To: Architects of Arcadia
Project: Galston Aquatic & Leisure Centre
Report: Access Assessment Report
Reference No: 109448.2b -Access-r3
Date: 25 November 2019
Client Contact: Rolfe Chrystal
Email: rolfe@architectsofarcadia.com.au
From: Christopher Ward
Direct: (02) 8484-4071
Email: cward@bcalogic.com.au

Revision	Date	Description	
109448.2b - Access-r1	17 Oct 2019	Access Assessment Report (DA Design Development Stage)	
109448.2b - Access-r2	12 Nov 2019	Access Assessment Report (DA Design Development Stage – updated plans)	
109448.2b - Access-r3	25 Nov 2019	Access Assessment Report (Minor update to the 'Location & Description')	
		Prepared by	Verified by
		Christopher Ward	Matthew McNamara
		Accredited Certifier Grade A3, No. BPB2789	Accredited Certifier Grade A1, No. BPB0263
		Building Regulations Consultant	Qualified Access Consultant ACAA Member No. 444

Figure 2. Accessway requirements

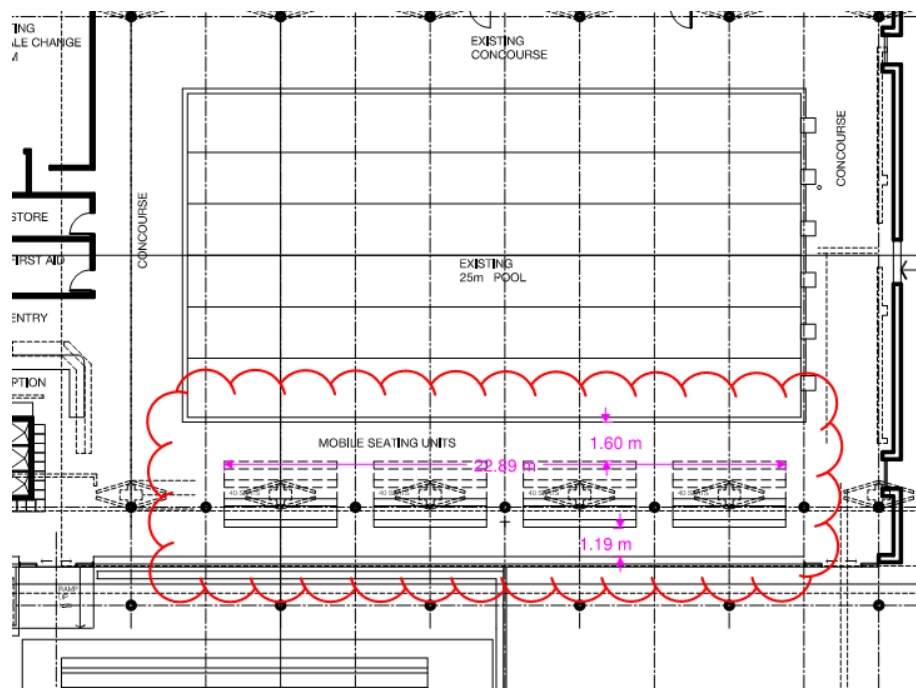
In accordance with BCA Clause D3.3(c)(ii)(B), accessways must have turning spaces (1540 mm wide by 2070 mm deep) complying with AS1428.1 at maximum 20 m intervals along the accessway.

The proposed plans indicate mobile seating units to be installed on the eastern side of the existing 25 m pool. The accessway between the seats and the pool and between the seats and the wall will be required to comply with the above accessway requirements.

Figure 5. Sliding door location.

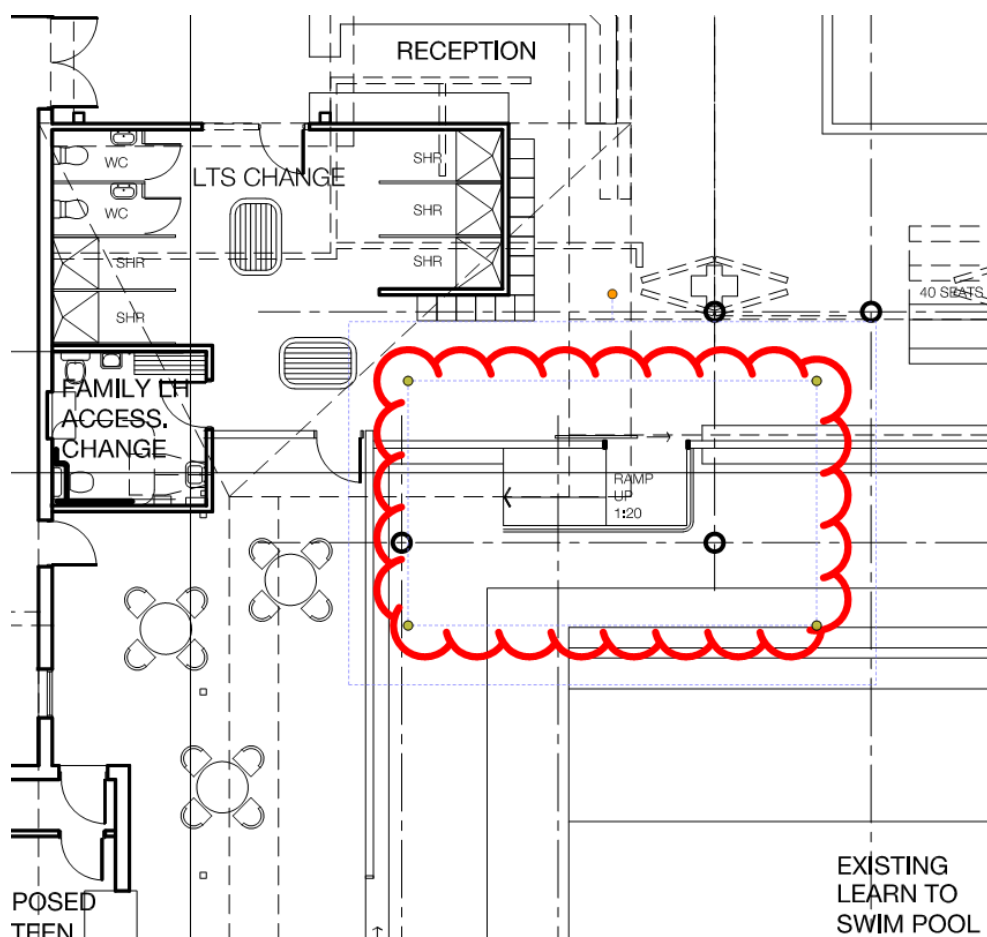
The proposed sliding doors located between the existing 25 m pool and the existing learner pool includes a walkway with a 1 in 20 gradient to the approach of the sliding doors. The doorway is required to be provided with a gradient and crossfall not steeper than 1 in 40.

Accordingly, doorway circulation space as required in Australian Standard AS1428.1-2009, Clause 13.3 is required to be provided to either side of the door. The doorway circulation space is required to have a gradient and crossfall not steeper than 1 in 40.

However if the sliding door is an 'automatic' sliding door, Clause 13.3.4 does not require latch-side and hinge-side circulation spaces and therefore a 1 in 20 gradient would be acceptable.
